Mask Set Errata for Mask 3K45H

This mask set errata applies to the mask 3K45H for these products:

- MC68HC908JB8

Power-Up from LVR

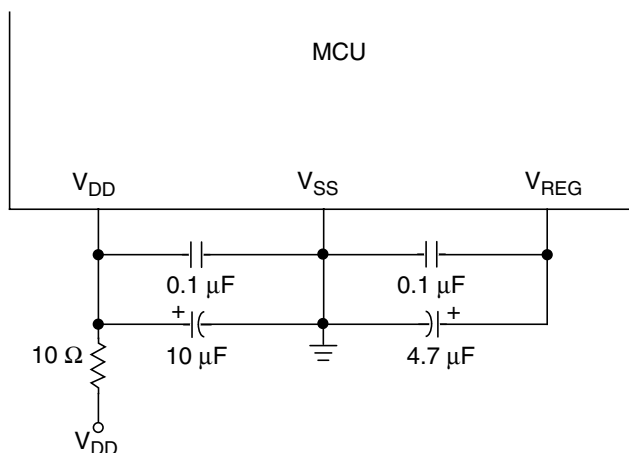
A few devices start abnormally during power-up. The issue is the release of the low voltage reset (LVR) earlier than the V_{REG} reaching the CMOS logic operating voltage (typical 0.65 V).

The LVR takes the V_{DD} but not the V_{REG} as a reference. LVR exists until the V_{DD} reaches the LVR threshold voltage (V_{LVR}). The problem happens in few devices when the V_{DD} rises quickly and the V_{REG} rises slowly. If the LVR has been released but the V_{REG} doesn't reach the CMOS logic operating voltage, the LVR does not have any effect. This might cause the internal logic to improperly initialize and the MCU might not start normally.

Therefore, the V_{DD} voltage must be lower than the VLVR minimum (2.8 V) when the V_{REG} voltage reaches the CMOS logic operating voltage.

To fix the problem, add a 10 Ω series resistor between the power supply and the V_{DD} , and place a 10 μF capacitor at the V_{DD} pin and a 4.7 μF capacitor at the V_{REG} pin.

The figure below shows a typical timer buffered PWM output waveform, indicating the TOF and OC events.

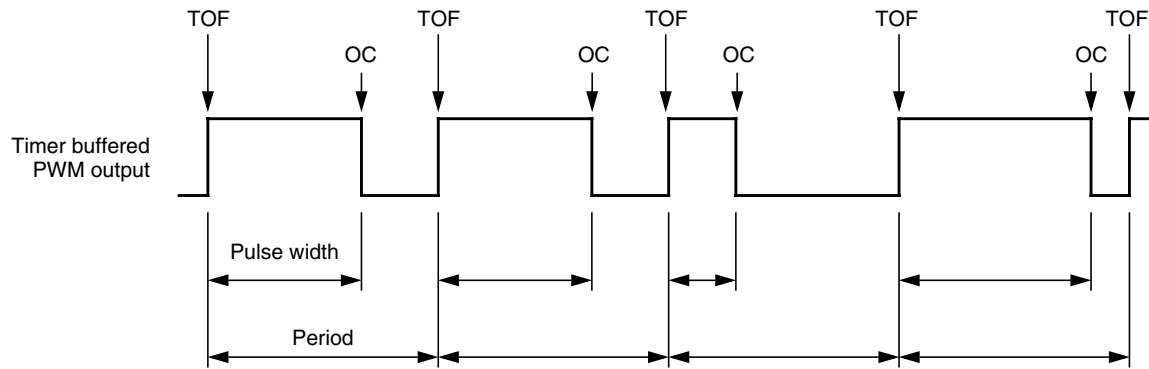
In timer buffered PWM operation, when a timer overflow (TOF) event or an output compare (OC) event coincides with a write to either pair of the timer channel registers (TCHxH/L), the duty cycle at the PWM output glitches to 0% or 100% momentarily, then returns to proper operation.

Do not write to either pair of timer channel registers at:
 TOF (timer overflow), or
 OC (timer output compare) edges.

To avoid the glitches when changing the PWM duty cycle, do not write to either pair of the timer channel registers at the TOF or OC.

For example, in the TOF interrupt service routine: If the OC occurs near the last TOF, write to the timer channel registers after the OC; if the OC occurs near the next TOF, write to the timer channel registers before the OC. A write to the channel register high byte (TCHxH) should immediately followed by a write to the low byte (TCHxL) to avoid TOF or OC occurring between the writes. Instruction cycle times must be included when making timing calculations.
